APPEAL SUMMARY

Status: Decision Rendered - Reconsideration of ID 18825

Appeal ID: 19044	Project Address: 6434 NE 42nd Ave
Hearing Date: 2/20/19	Appellant Name: Melissa Meiners
Case No.: B-013	Appellant Phone: 5037082157
Appeal Type: Building	Plans Examiner/Inspector: Chanel Horn
Project Type: residential	Stories: 2 Occupancy: R-3, U Construction Type: V-B
Building/Business Name: Fernhill Crossing	Fire Sprinklers: Yes - Throughout Building
Appeal Involves: Reconsideration of appeal	LUR or Permit Application No.: 18-186031-RS, 18-253148-CO
Plan Submitted Option: pdf [File 1] [File 2] [File 3]	Proposed use: Duplex, Carport

FERNHILL CROSSING

1 / SITE PLAN - BUILDING DIMENSIONS
scale: 1" = 20'-0"

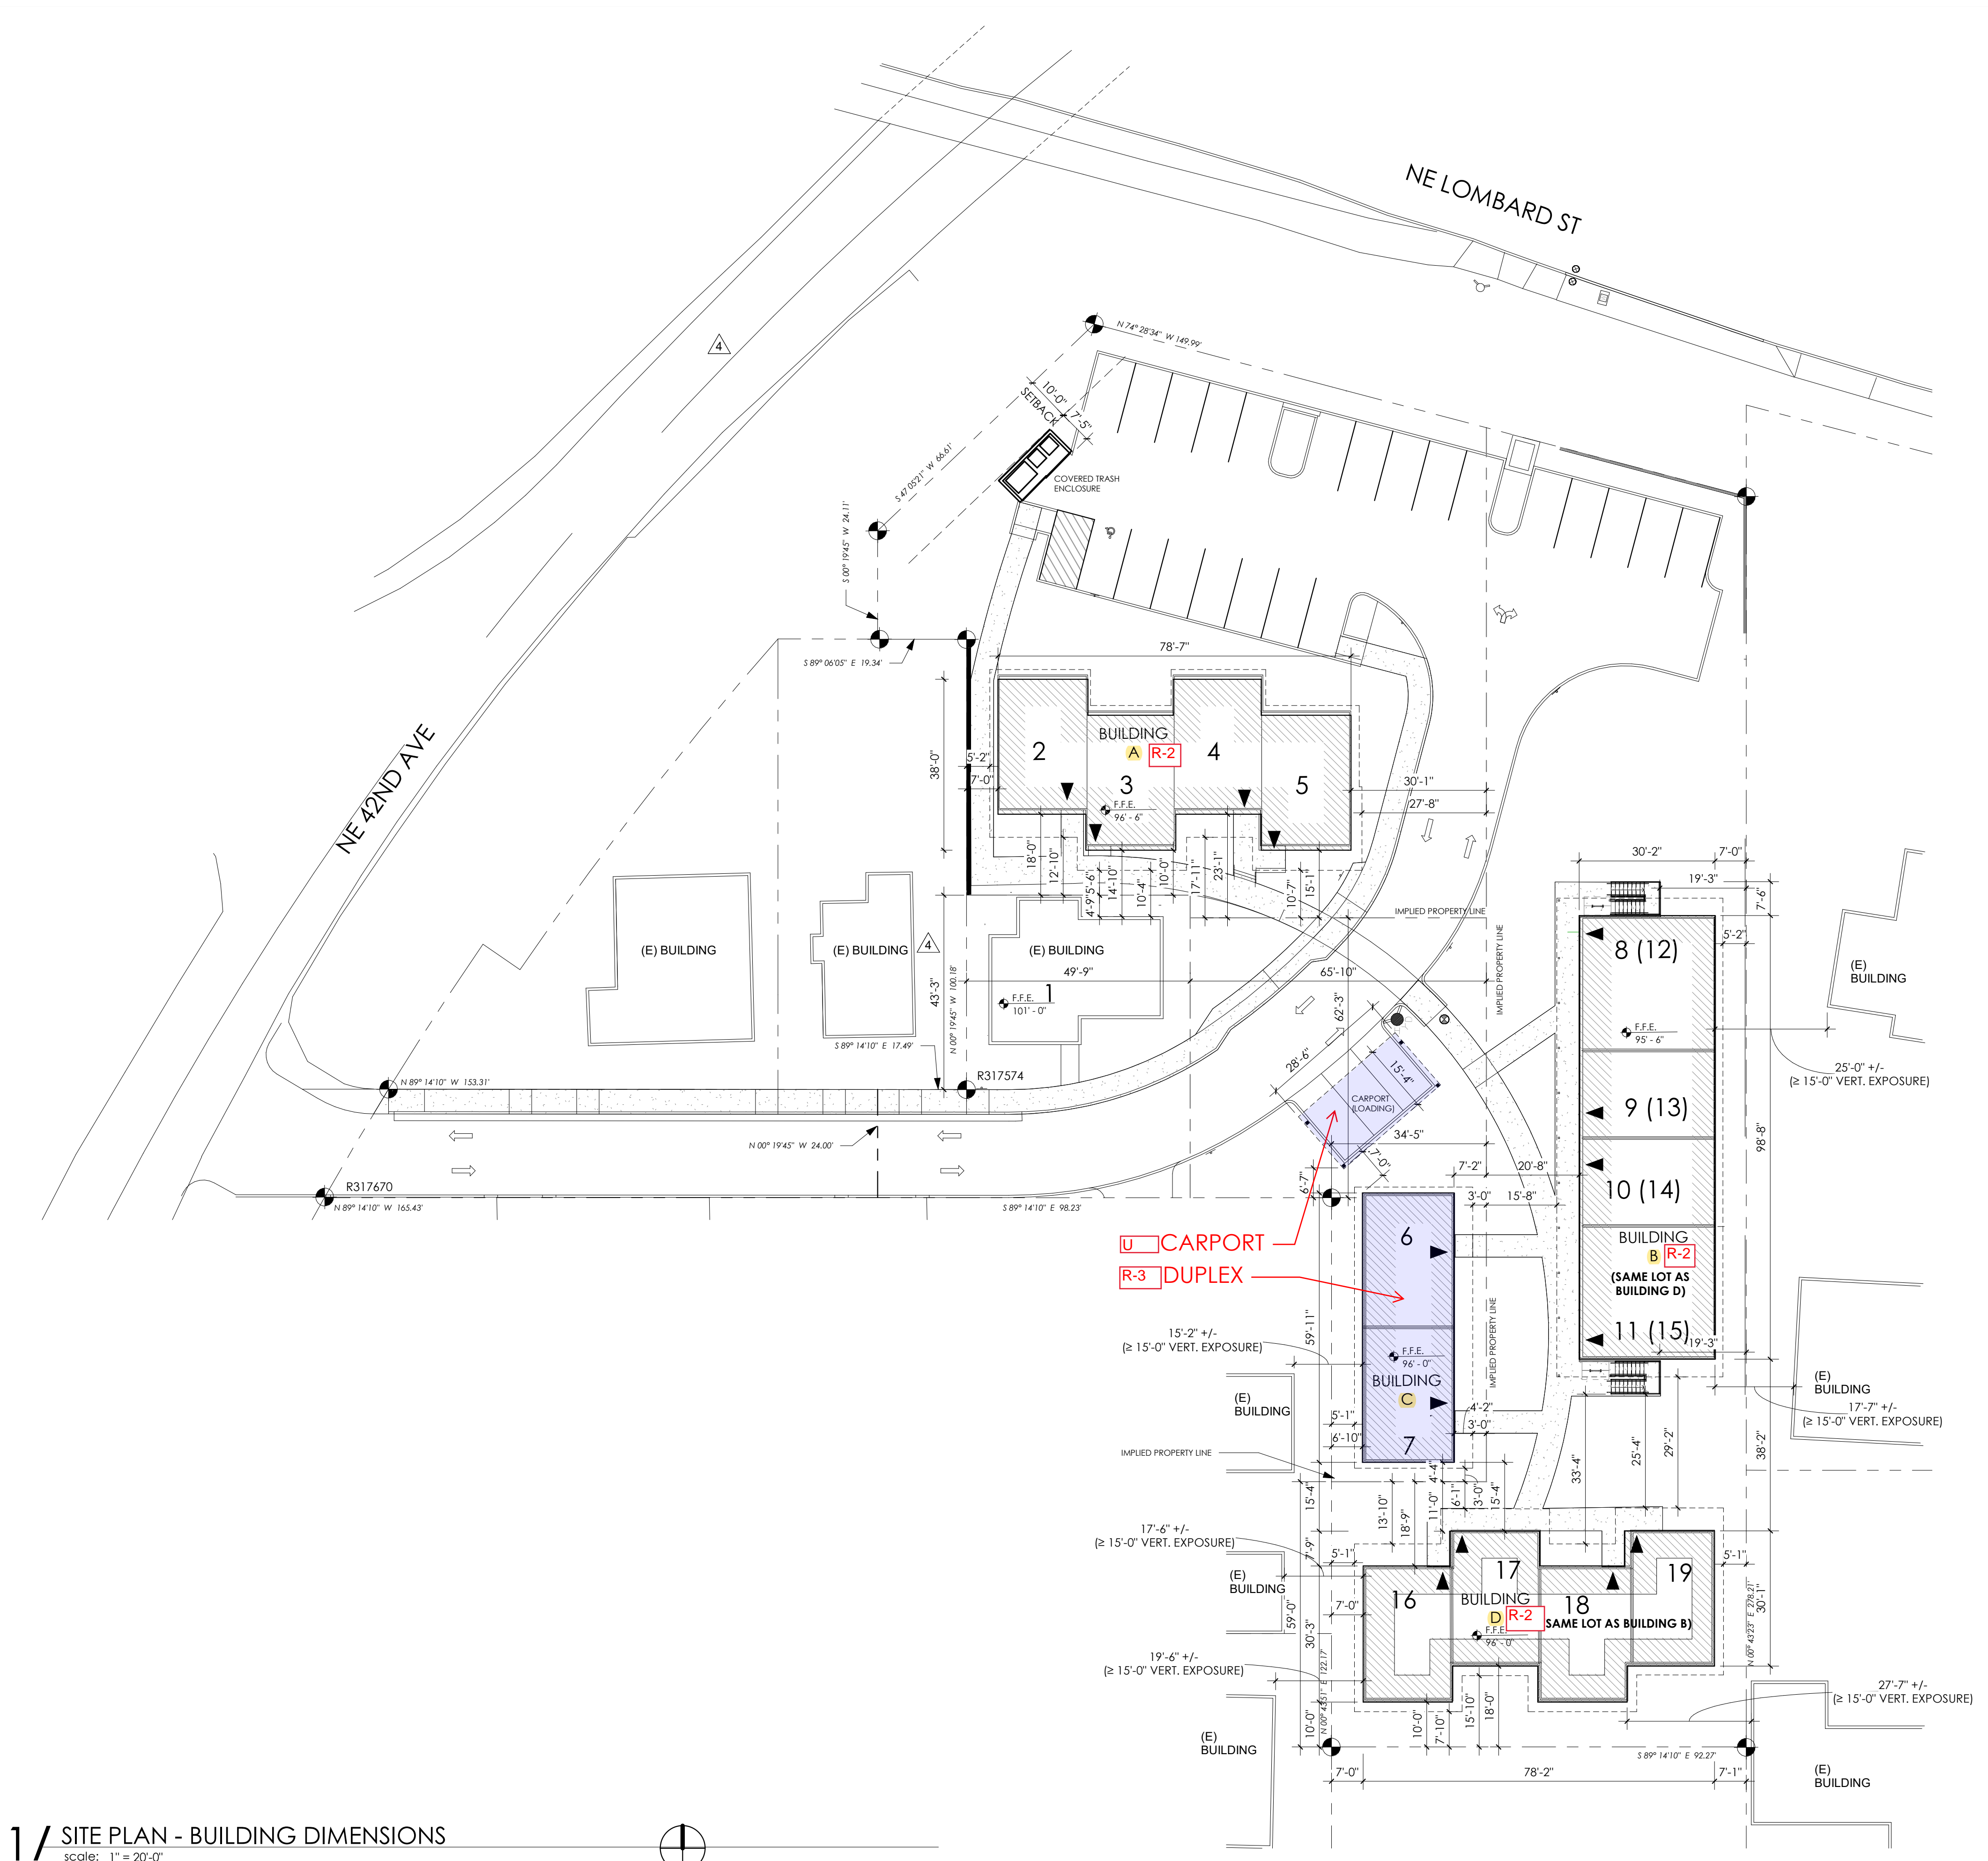
Reason for alternative The two-family dwelling unit was initially submitted for a building permit under the OSSC but was requested upon submission to be regulated under the 2017 ORSC. The carport was accepted as designed under the 2014 OSSC. Because the 2 structures (carport and duplex) have been deemed to be regulated under the two different codes, this would require an implied property line and fire separation.

The intent of the appeal was to demonstrate that equivalent life-safety and fire protection is provided whether the 2 structures are regulated under the same code, or whether regulated under different codes. There is no defined path that spans both codes that provides requirements for 2 buildings on the same lot that are regulated under different codes. OSSC Section 503.1.2 provides requirements for buildings on the same lot but the scoping of the OSSC does not include one- and two-family dwellings.

Under the ORSC, the carport would be considered an accessory structure to the duplex, and fire-resistance construction is not required per Section R302, Exception 2, as it relates to Table R302.1.

Under the OSSC, if considered as 2 buildings on the same lot, fire-resistance separation would not be required because the aggregate area of both structures is well within the allowable area for U occupancy classification, per Table 503.

Fire-resistance construction not be required between the duplex and carport.

Omission of fire resistant rated construction as separation between ORSC duplex and OSSC carport: Granted as proposed.

CARPORT DRAWINGS

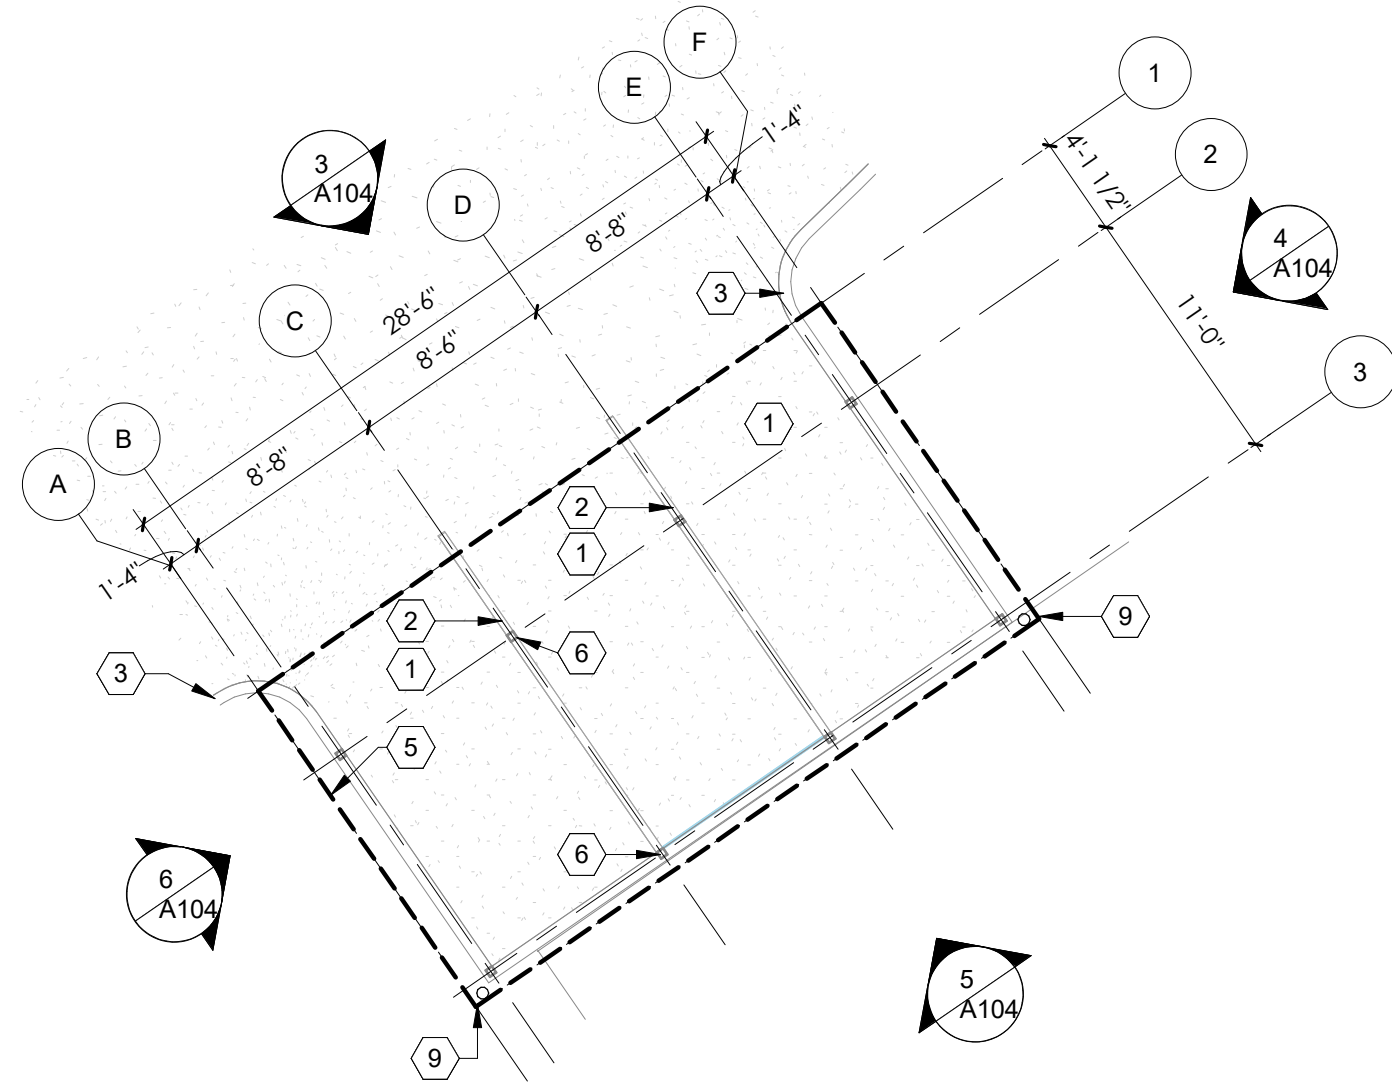
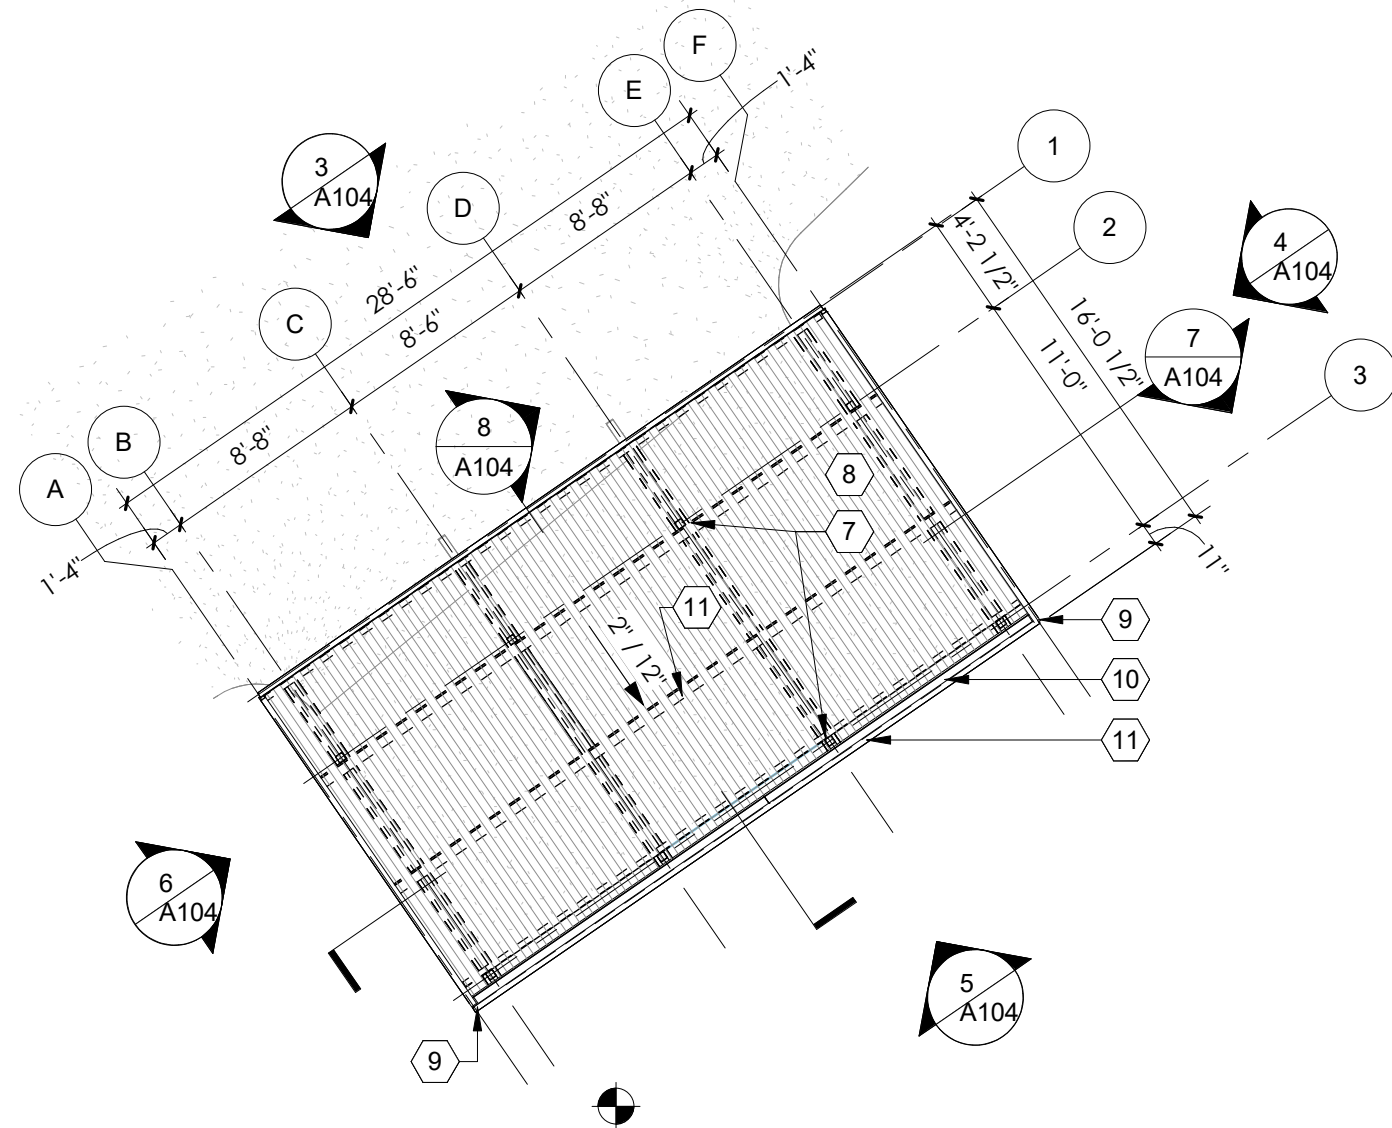
Proposed Design	<p>The two-family dwelling unit and carport are part of a larger planned unit development that also includes (3) buildings with multi-family dwelling units.</p> <p>The duplex is 2-stories, Type VB construction, and will be fully-sprinklered per NFPA 13R.</p> <p>The carport is 1-story, constructed entirely of non-combustible materials with no concealed spaces: concrete footings, steel columns, and metal decking roof.</p>

The use of the carport is for short-term vehicle loading, not permanent long-term parking.

The area of the carport is very small at 472 square feet.

The carport is open on all 4 sides.

- a. The duplex will be sprinklered per NFPA 13R, although not required by the ORSC.
- b. The carport is constructed entirely of non-combustible materials with no concealed spaces; concrete footings, steel columns, and metal decking roof.
- c. The carport is fully open on all 4 sides.
- d. The use of the carport is for short-term vehicle loading, not permanent long-term parking.
- e. The area of the carport is very small at 472 square feet.
